Bid Addendum

PWC Number: PWC2223058

Bid Title : Big Rockfish Creek Outfall Contract II

Addendum Number: 4

**SS-3 - TYPICAL TRENCH BOTTOM AND BACKFILL
DETAIL FOR SDR 26 AND C900 PVC PIPE
(SANITARY SEWER) REV PER ADDENDUM 4
N.T.S**

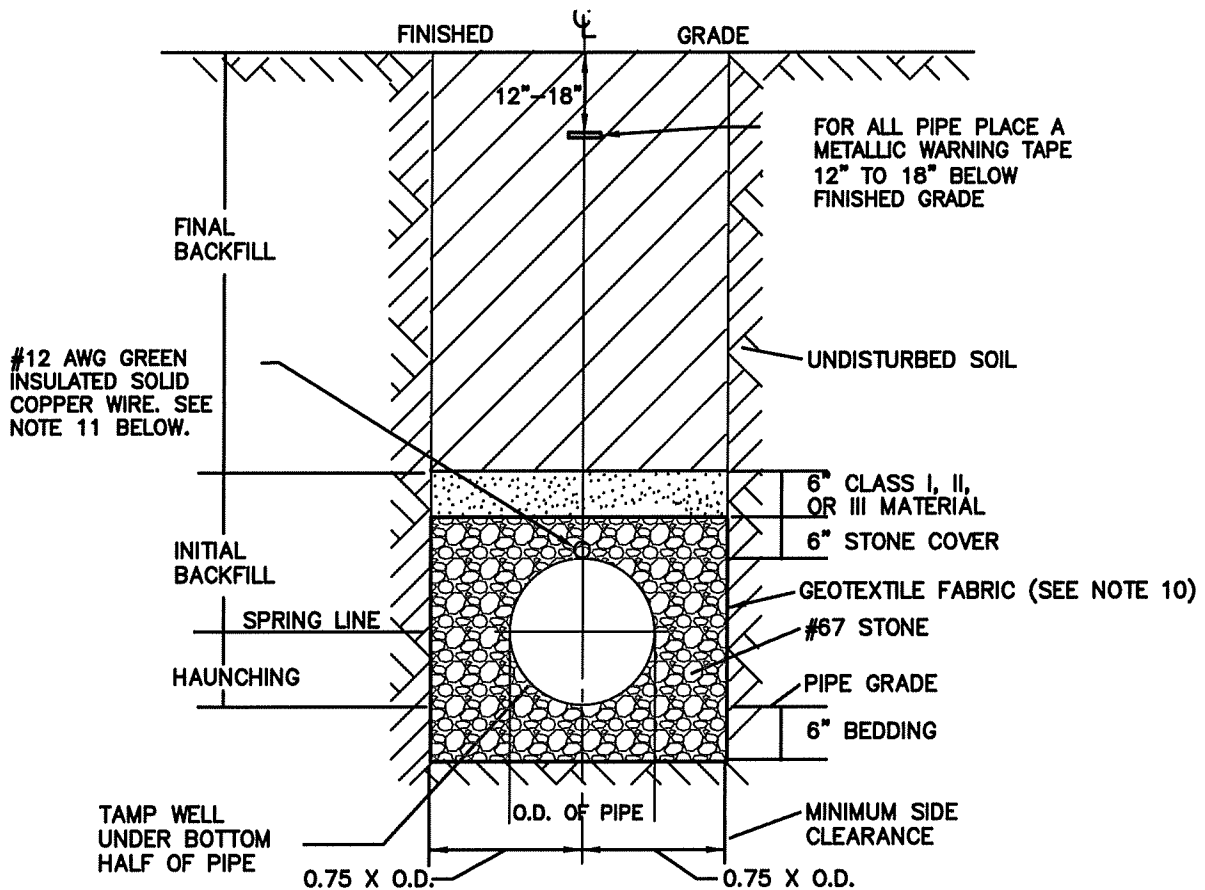
- M2. *Detail SS-3=Typical Trench Bottom and Backfill Detail for SDR 26 and C900 PVC Pipe per Addendum 3 shall be replaced in its entirety with the enclosed revised Detail SS-3. The revised detail shall become part of the details included in the issued for bid drawings.*

6. ACHIEVE 90% COMPACTION IN BEDDING, HAUNCHING AND INITIAL BACKFILL. SEE CONTRACT DOCUMENTS FOR COMPACTION REQUIREMENTS IN FINAL BACKFILL.
7. IF IN MAINTAINED/MANICURED LAWN OR WHERE SOD IS REQUIRED FOR RESTORATION, PROVIDE 4" TOPSOIL, AND 12" CLEAN SELECT FILL FOR FINAL DRESSING OF TRENCH BACKFILL.
